TO: Vickie Huang	FROM: Trevor Kurth
COMPANY: City of Wichita	DATE: 11/18/04
ADDRESS:	PROJECT: Southern Ridge 3rd
CITY/STATE: Wichita, Kansas	PROJECT NUMBER: 04-10-P491

RE:
Drainage & Grading Plan

STAFF REPORT
(Final Portion of Overall Preliminary Plat)

CASE NUMBER: SUB 2004-138 -- SOUTHERN RIDGE THIRD ADDITION

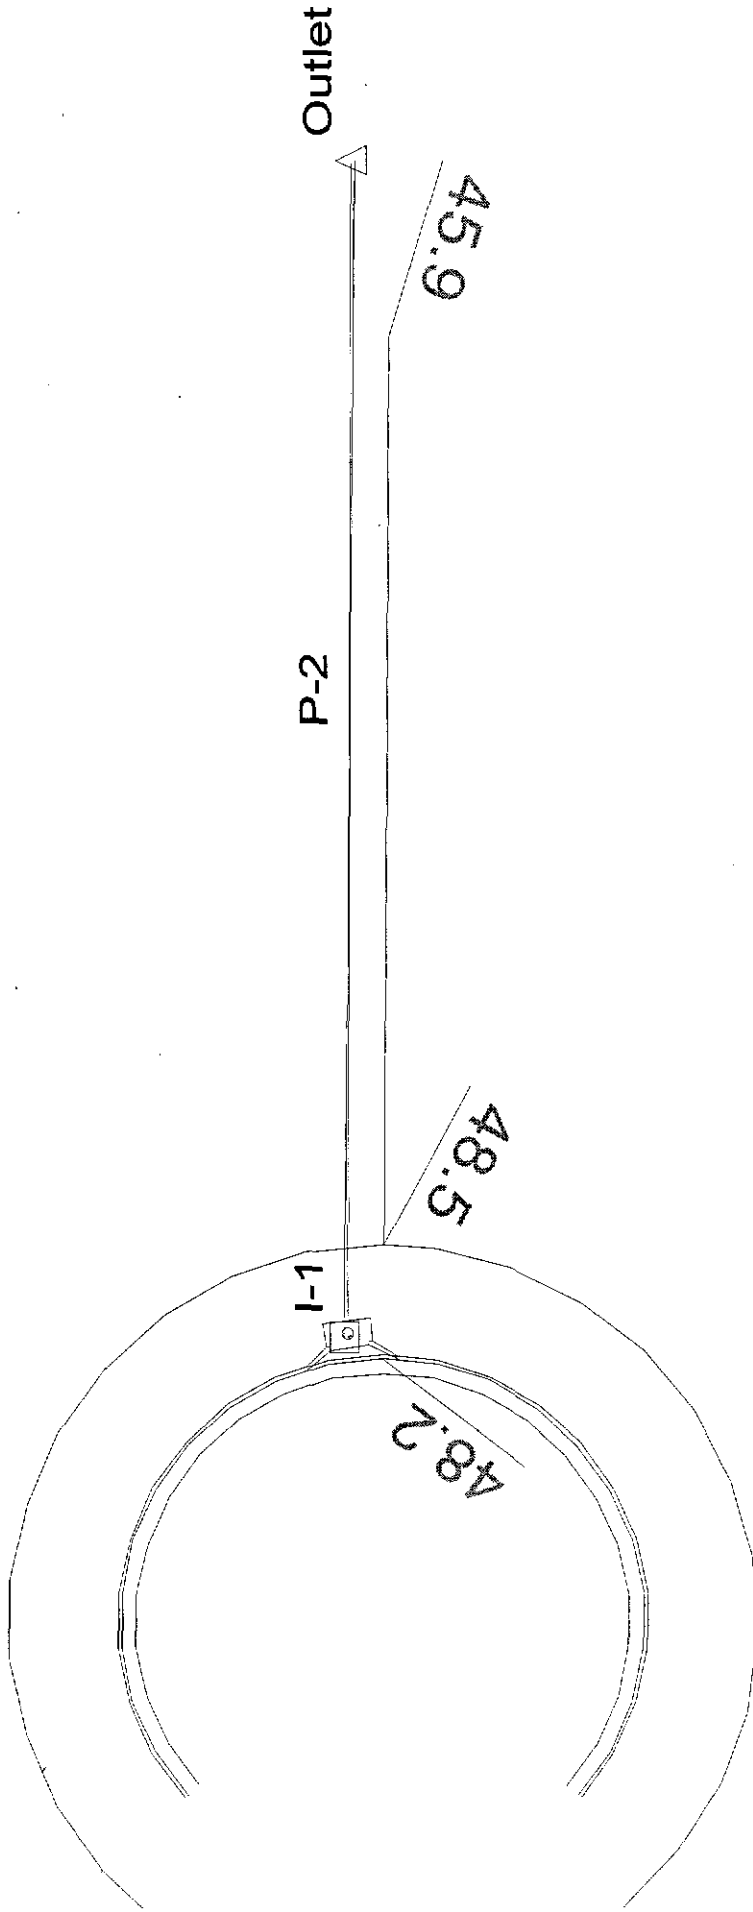
- H. **GIS** needs to comment on the plat's street names. **Street names need to be revised in accordance with those requested on the overall preliminary plat of Southern Ridge Addition.**

- I. The right-of-way width for Dallas St. is incorrectly depicted.
- J. Prescott Ct. should be denoted as a 58' right-of-way.
- K. The Applicant is reminded that a platting binder is required with the final plat. Approval of this plat will be subject to submittal of this binder and any relevant conditions found by such a review.
